Amendments to the Drawings

Attached are replacement drawing sheets for Figures 1 and 2 of this application. The following changes are contained on the replacement drawings.

FIG. 1 (PRIOR ART)

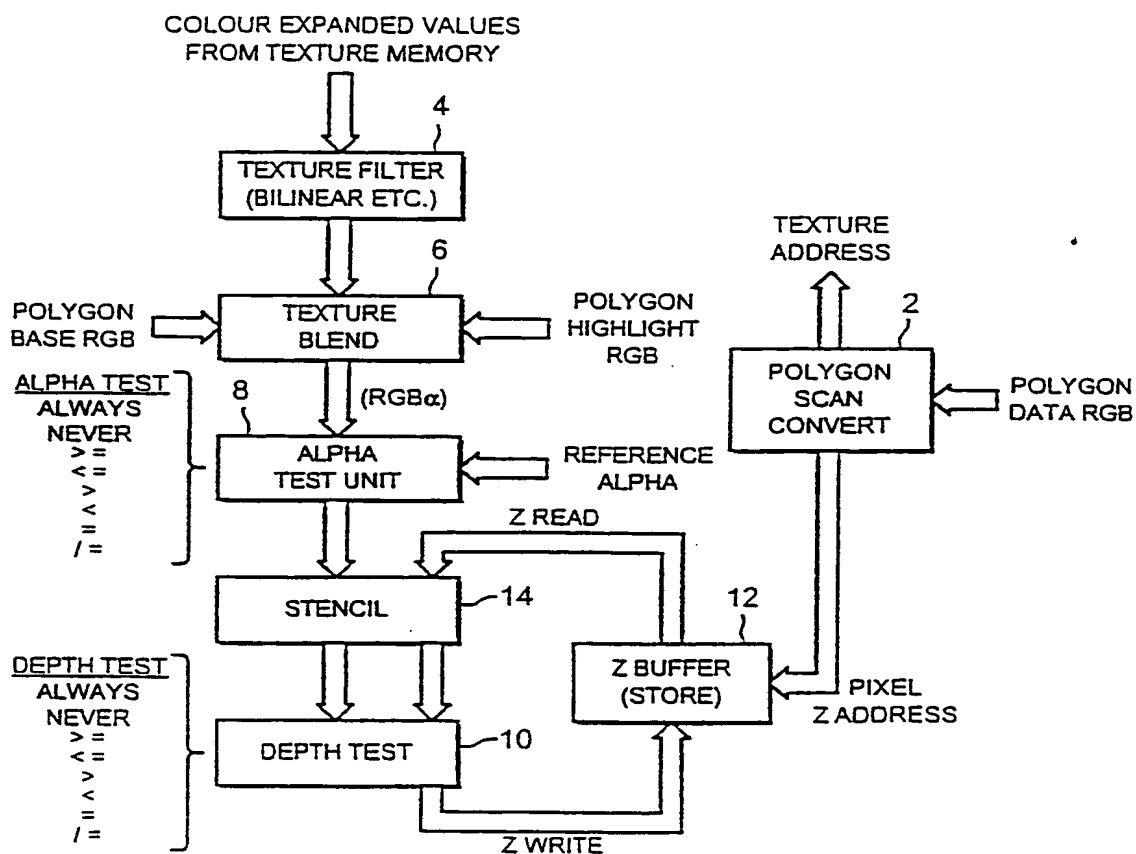
The legend "PRIOR ART" is added to these drawings to indicate that, as set forth in the application, these drawings are directed to prior art technology. (Original Specification, page 5, lines 25-28.)

FIG. 2 (PRIOR ART)

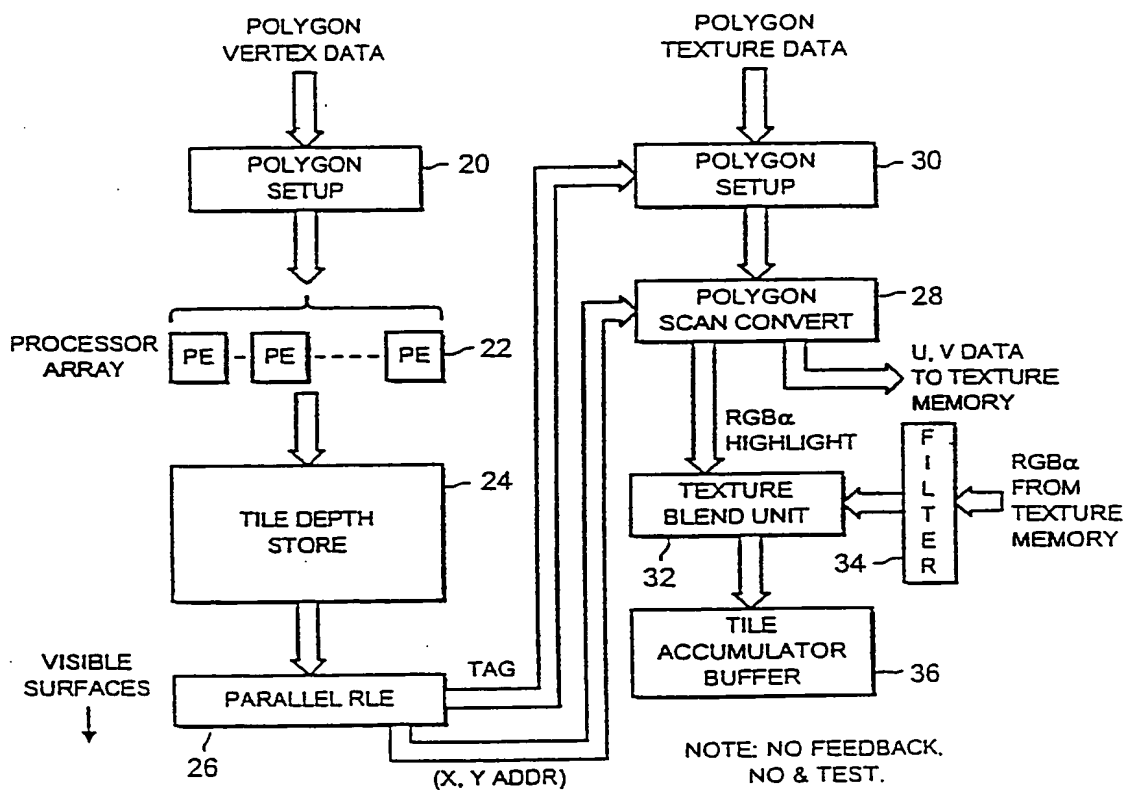
Change the identification number associated with the polygon scan convert unit from "38" to "28". This change is made to identify this component consistent with the identification number employed in the application. (Original Specification, page 4, lines 13-14.)
